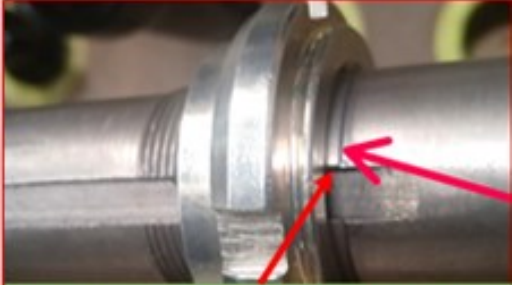
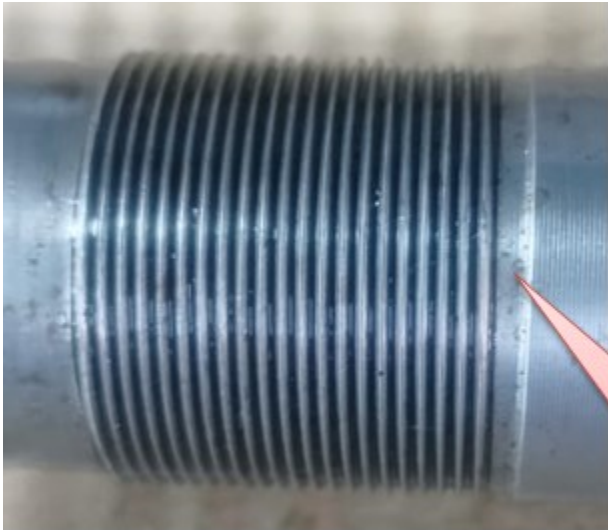
Gap observed after tightening of matting part or Matting part not answering till groove end

No thread minor diameter mark in groove

Thread minor diameter mark in the groove to answer the gauge till last

NO Gap ,gauge answering till groove end.
